IDAP REPORT

Property:	13 Victoria Street STRATHFIELD
Proposal:	DA 2020/110 Demolition of existing building and construction of a two storey dwelling with basement level, inground pool, boundary fencing and associated landscaping.
Applicant:	N Lycenko
Owner:	Yan Liu
Date of lodgement:	19 June 2020
Notification period:	1 July 2020 to 15 July 2020
Submissions received:	2
Assessment officer:	J Gillies
Estimated cost of works:	\$1,815,237.00
Zoning:	R2-Low Density Residential - SLEP 2012
Heritage:	No
Flood affected:	No
Is a Clause 4.6 Variation Proposed:	Yes, FSR 0.58:1 (19.7%)
RECOMMENDATION OF OFFICER:	REFUSAL

Figure 9 – Proposed First Floor Layout

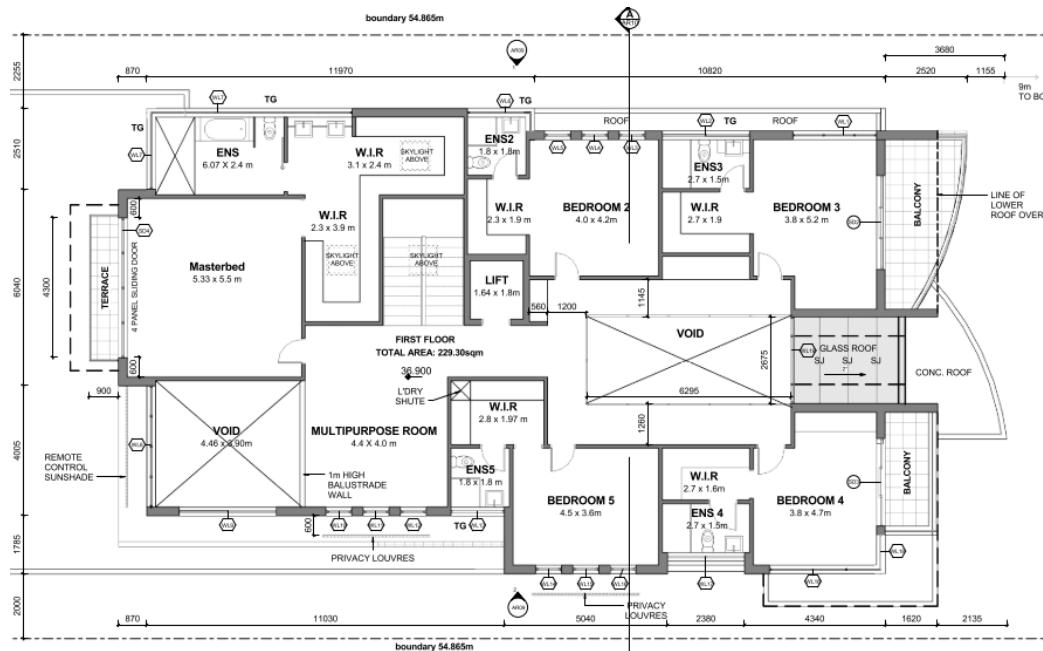
The proposed dwelling house exceeds the FSR allowance under Part 4.4 of the LEP. Gross floor area plans submitted with the Application exclude the area of a first floor void and the basement (excluding the bathroom). Figures 9 to 11 below show the first floor, first floor GFA calculation submitted by the Applicant and Basement.

The Applicant's FSR calculations suggest the total GFA is 508.3m² with an FSR of 0.497:1. However, this calculation excludes the first floor void located at the north western corner which has the dimensions and floor to ceiling height of a bedroom or habitable room of some sort. The Applicant was advised to include the area of this void in GFA calculations and revise the design to fit within the allowable GFA. The option of lowering the roof height in the location of the void to restrict the floor to ceiling height to 2.1m was suggested by Council, however the Applicant did not accept this suggestion.

As such, the rear void which has an area of 17.4m² has been included in the GFA and FSR calculations for the proposal.

Figure 11 – Proposed Basement

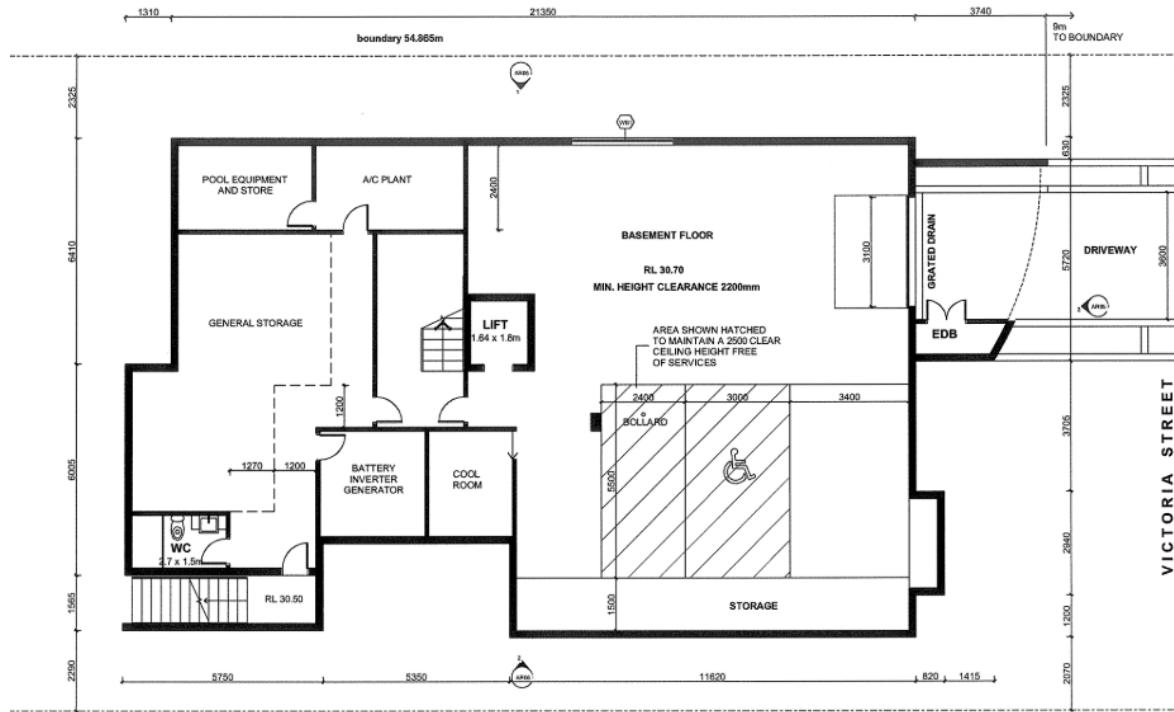
The Applicant's FSR calculations do not include areas of excessive storage and parking surplus within the basement.

In the revised Architectural Drawings submitted with the Application (refer to Figure 11), the Applicant responded to the request to justify excessive storage spaces with illustration of partitions and labels for various different storage purposes. While the size of most storage spaces are excessive, these have been accepted. However, the General Storage space is not justified and presents as a space that could be used for a home theatre or the like.

The third car space has also been included in GFA calculations and the Applicant's use of an illustration showing a wheelchair accessible car space is not relevant considering the development will be required to comply with BCA standards and the basement includes a lift.

Accordingly, these areas have been included in the FSR calculation undertaken as part of this assessment and contribute to an exceedance of the allowable GFA.
